Addendum

Submission to the Nunavut Water Board

Jericho Diamond Project

October 8, 2004

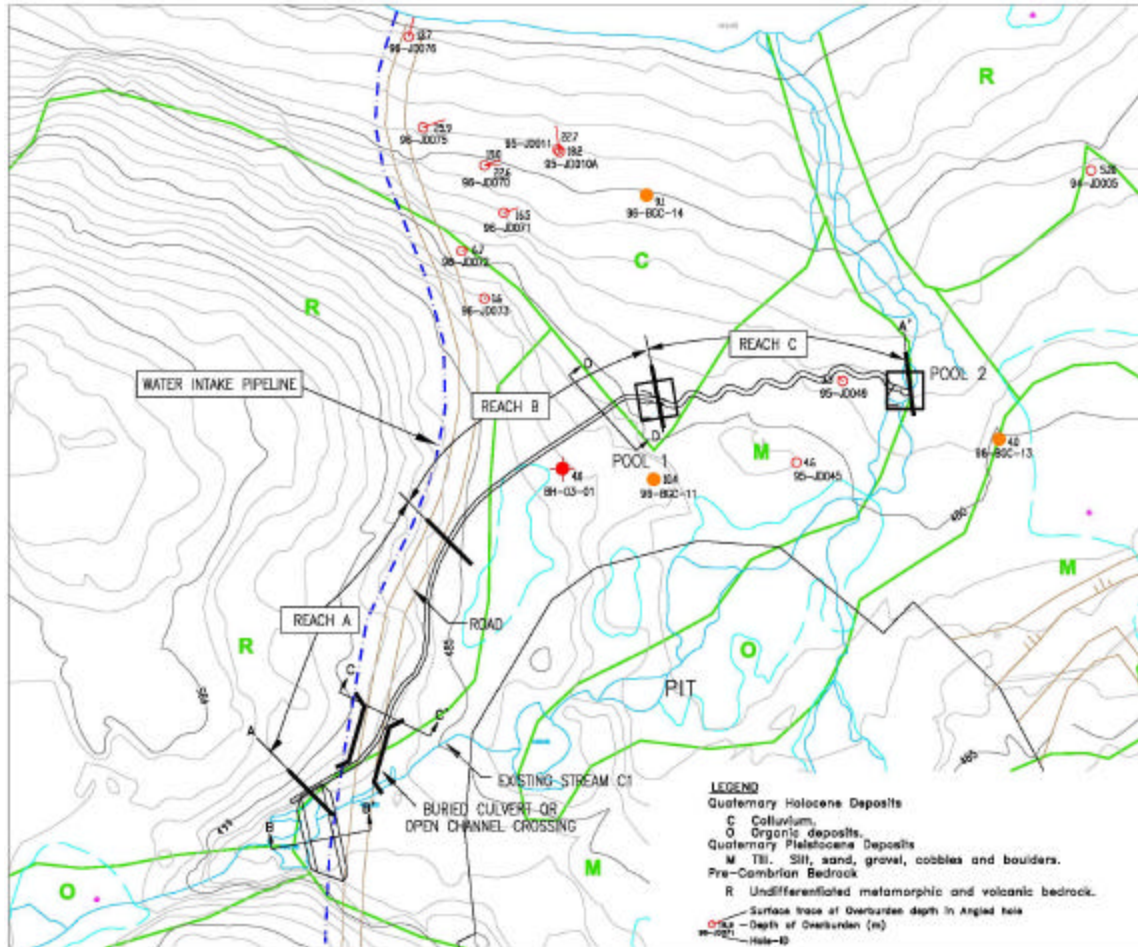
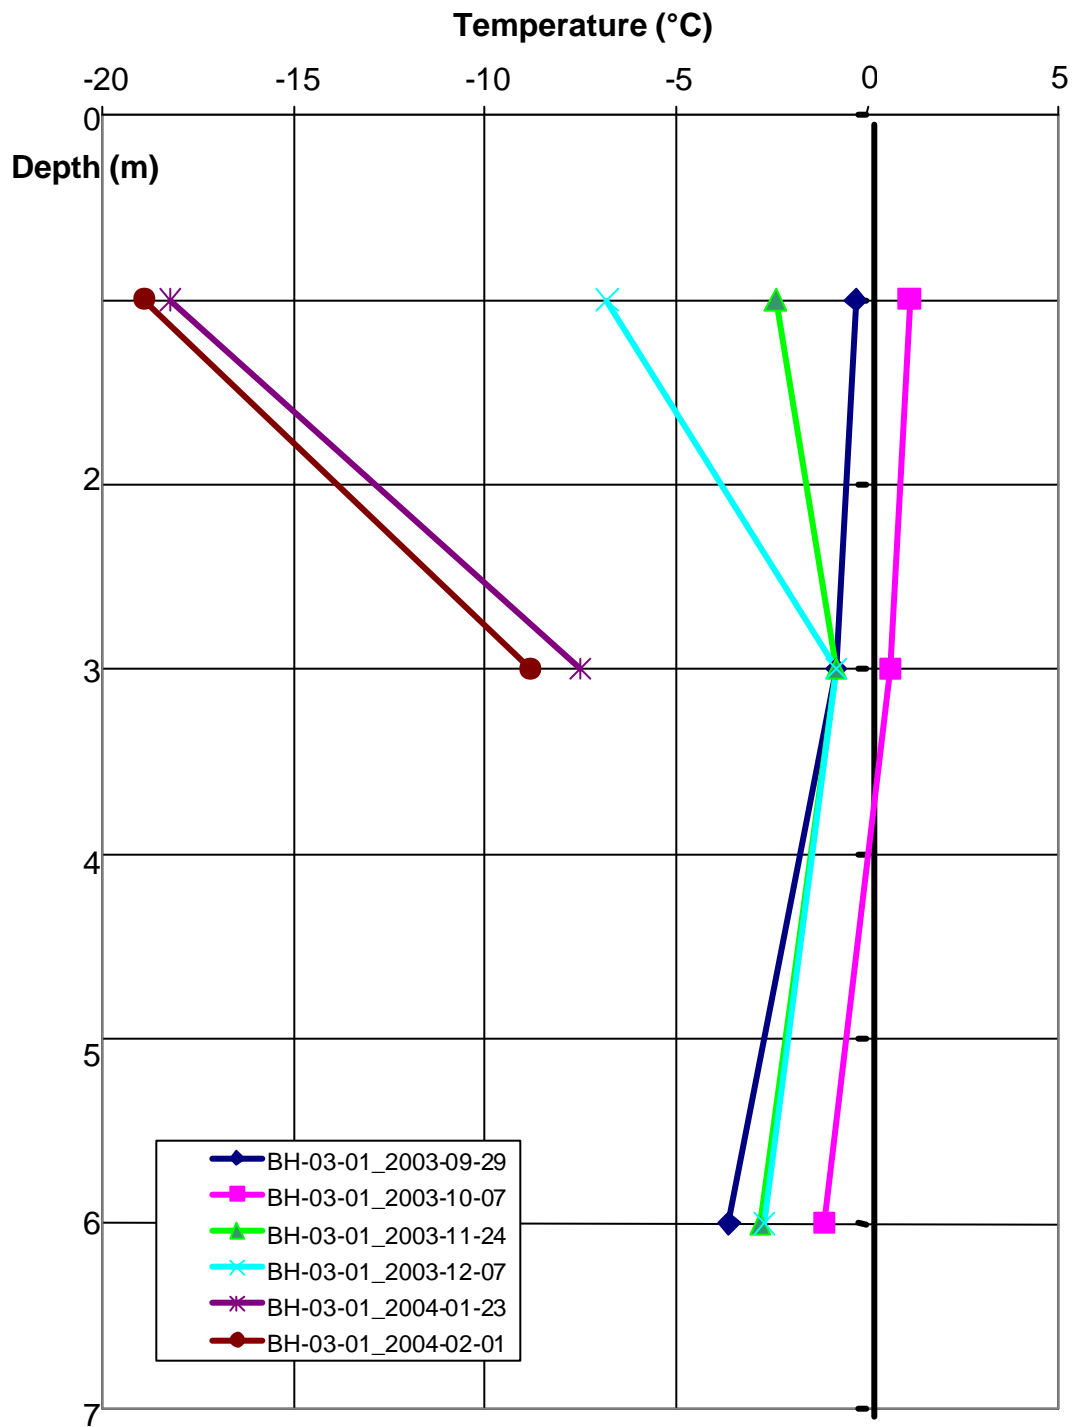
**NWB Comment:** No ground conditions provided.

The surficial geology in the vicinity of the diversion ditch is provided on the following figure. This figure also shows the locations of boreholes completed in the general vicinity of the C1 Diversion and the thickness of soils encountered at each of these borehole locations. Detailed geotechnical and ground ice data of relevance to Reaches B and C is provided on the logs for boreholes 96-BGC-11, 96-BGC-13, 96-BGC-14 and BH-03-01, copies of which are provided in Appendix BB (SRK Technical Memorandum A, Attachments A.4 and A.6).

Boreholes 96-BGC-11, 96-BGC-13 and 96-BGC-14 provide detailed information on ice content in the local soils proximal to the C1 Diversion. In addition, site specific geothermal data is provided by the thermistor in borehole BH-03-01. The location of each of these boreholes is provided on the layout plan, above. The logs for boreholes 96-BGC-11, 96-BGC-13, 96-BGC-14 and BH-03-01 are provided in Appendix BB (SRK Technical Memorandum A).

**Graphical Output of Select Temperature Data from Thermistors at BH-03-04**

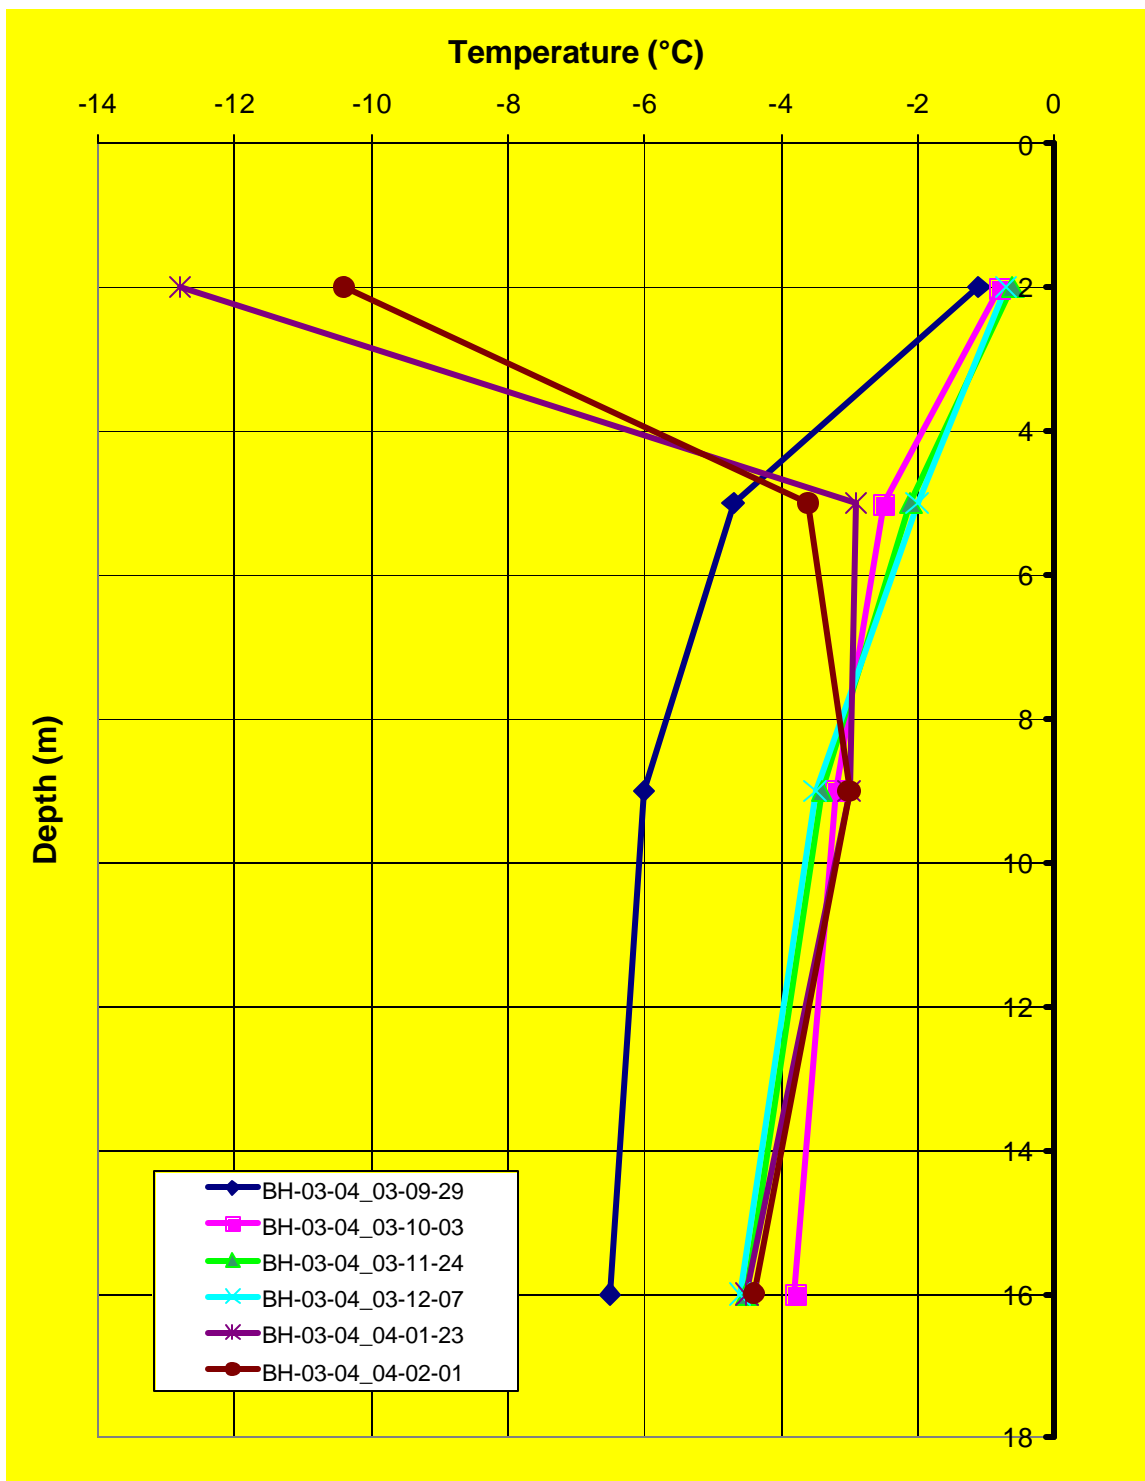
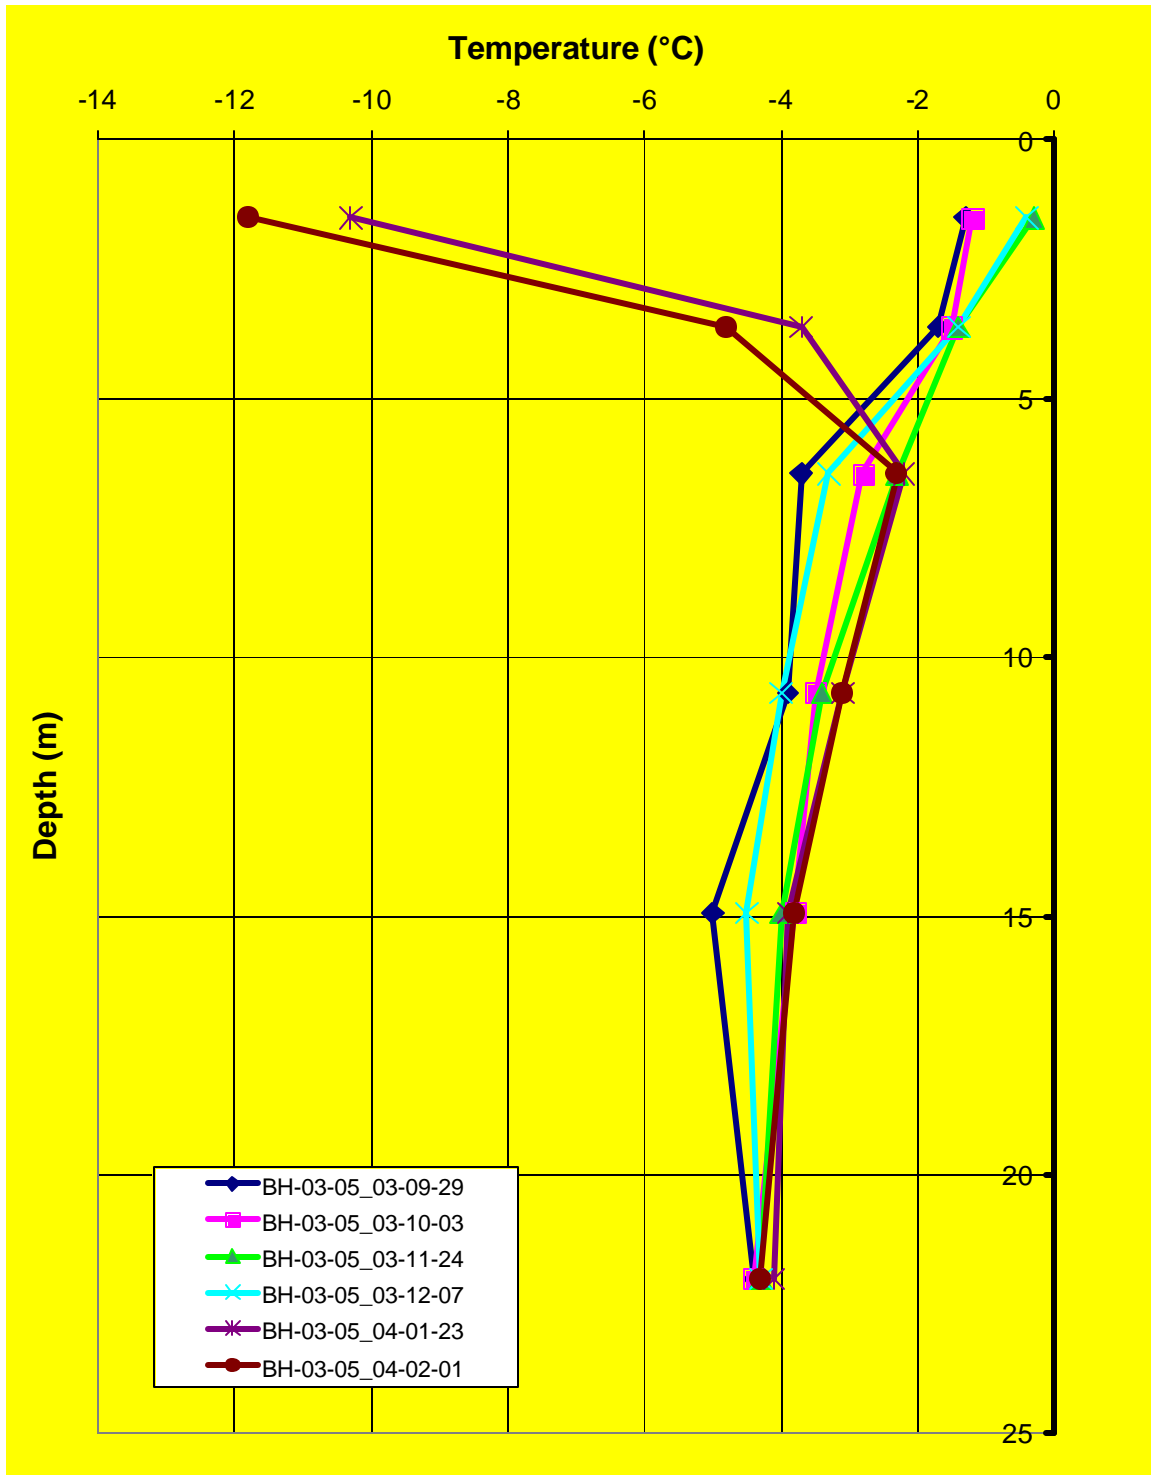
**NWB Comment:** Confirm potential taliks.

Additional technical data which supports the conclusion that any talik, if present, is thin are the thermistor plots from two boreholes in the valley floor (BH-03-04 and BH-03-05). The locations of these two boreholes are shown on Drawing 1CT004.06-G4 (included in Appendix S of the Tahera Water Permit Submission). The thermistor data from these two boreholes is provided on the following two figures, which indicates that the ground temperature in the valley is similar to the general permafrost temperatures elsewhere at the site.

**LANDFILL LAYOUT DRAWING  
FOR WATER LICENCE**

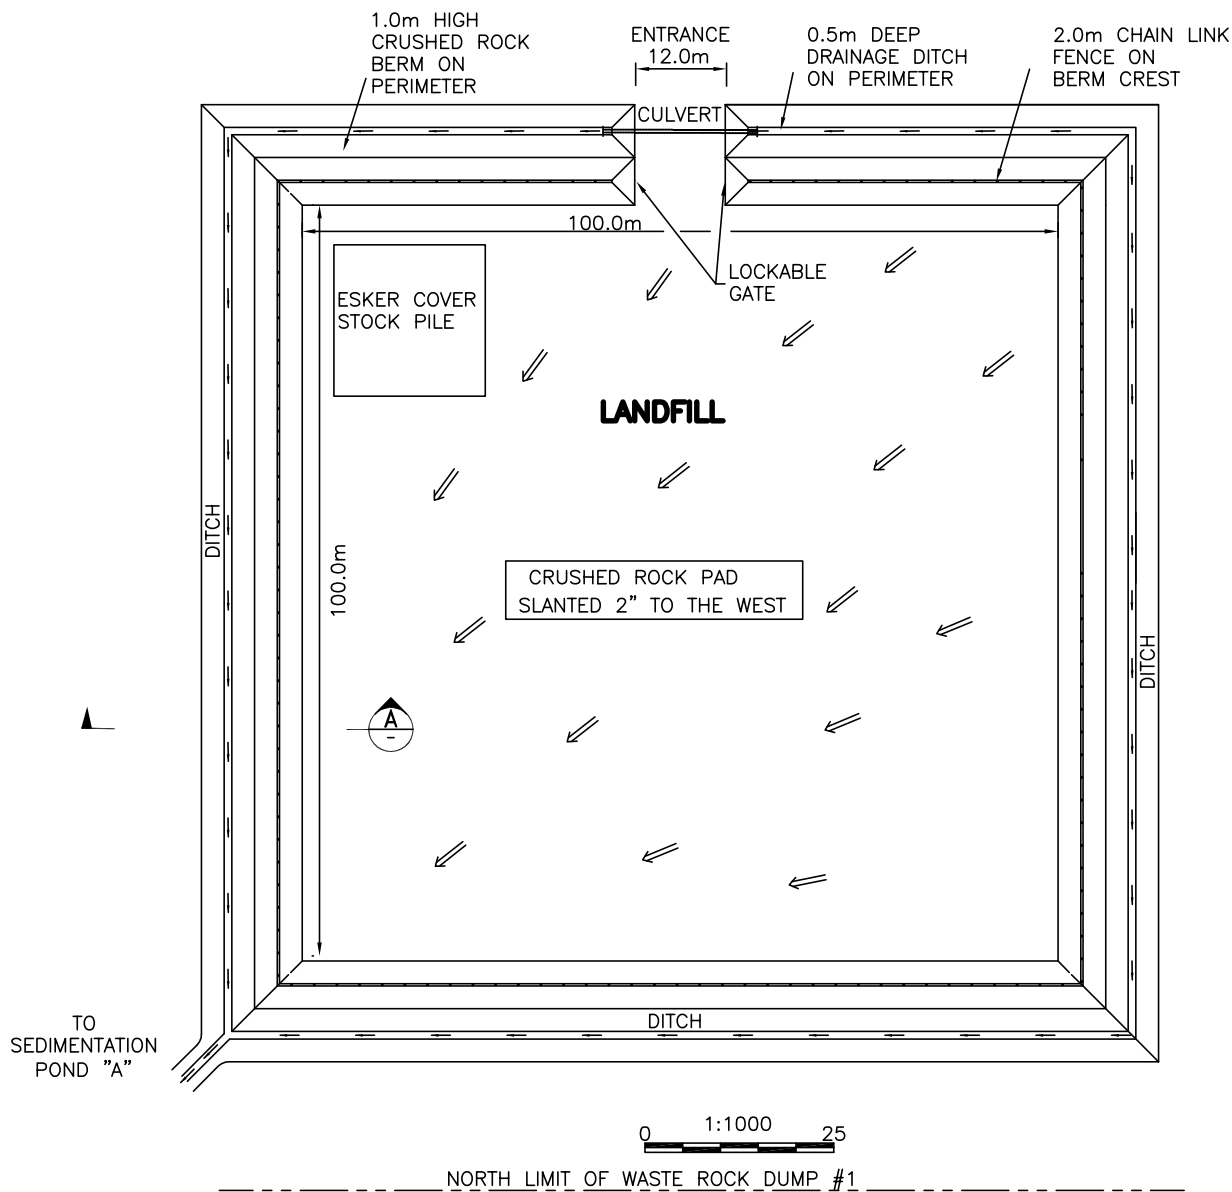
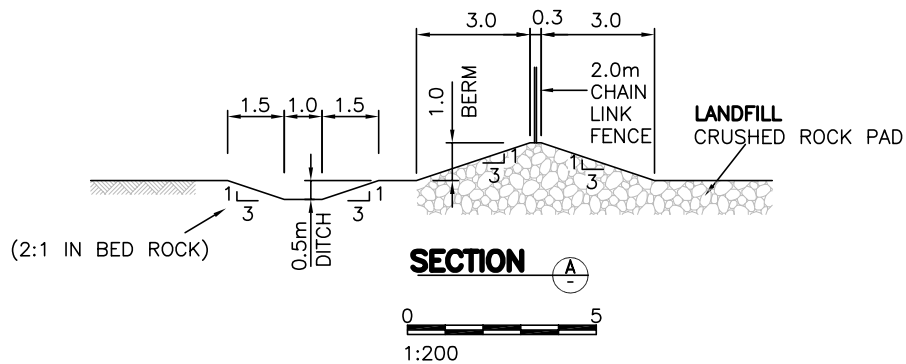
**NWB Comment:** re. landfill management, no design plan provided for landfill, no monitoring or details on maintenance.

**Response:**

Design of the landfill is in Figure 1 of the Landfill Management Plan, P. 3 which may have inadvertently been omitted from the Application and is therefore attached.

DRAWING NO. DESIN: A1-K17296-7868

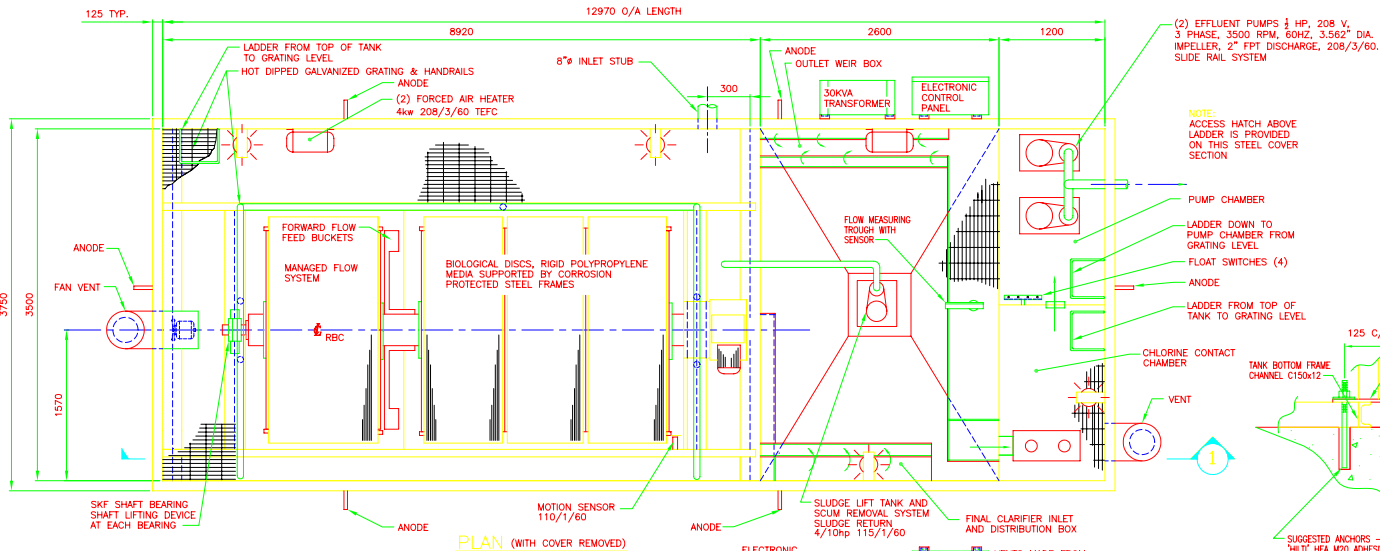
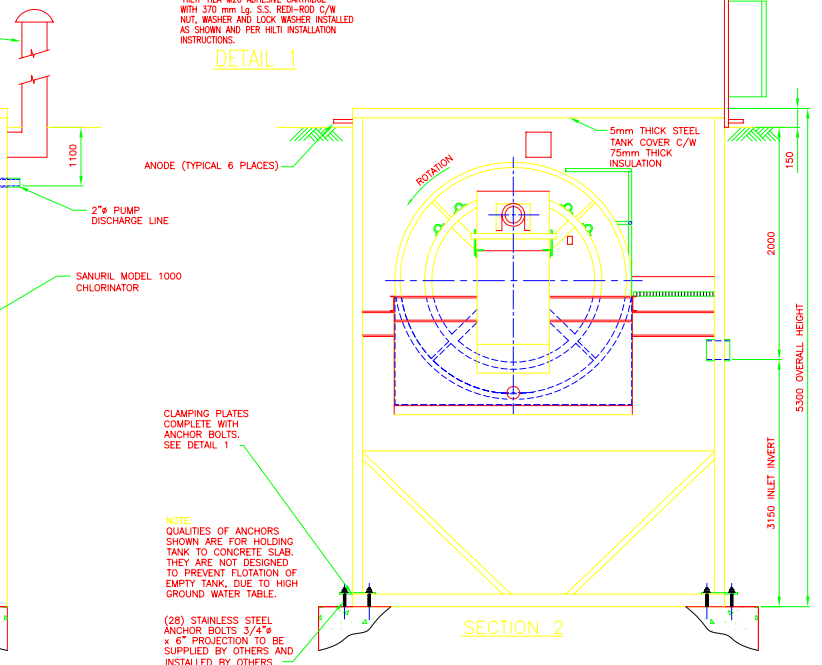
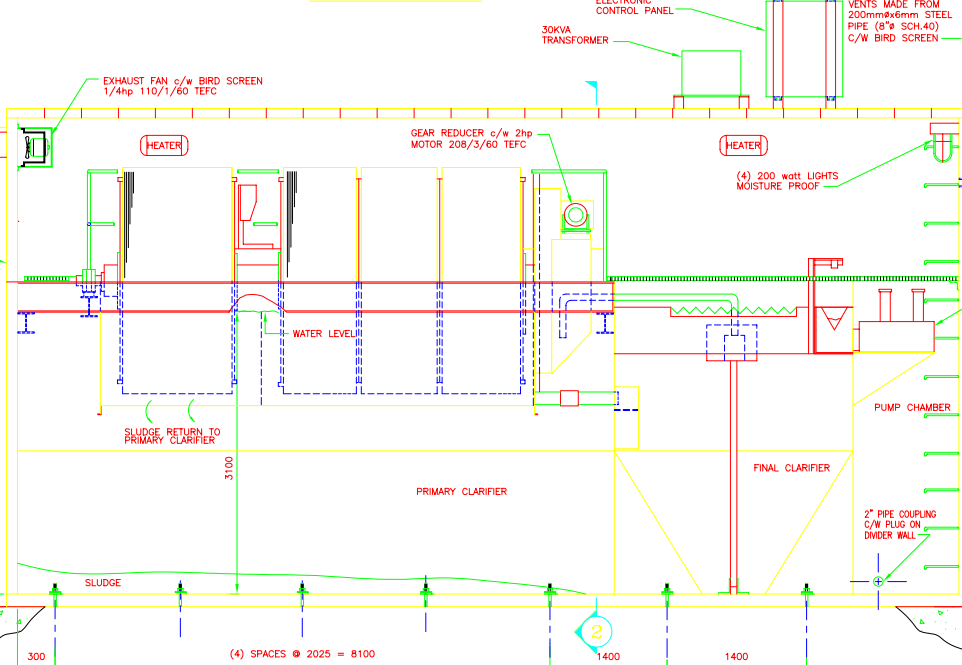
**NWB Comment:** re. waste water treatment plant, detailed design specification was not provided.

The attached AutoCAD drawing shows the treatment plant we supplied for North American Palladium several years back. While this is a good example of our factory-built packaged camp plants, it is considerably larger than your application (350 men vs. 100 men). At your request, we would be pleased to provide a basic lay-out drawing for a system suitable for your application.
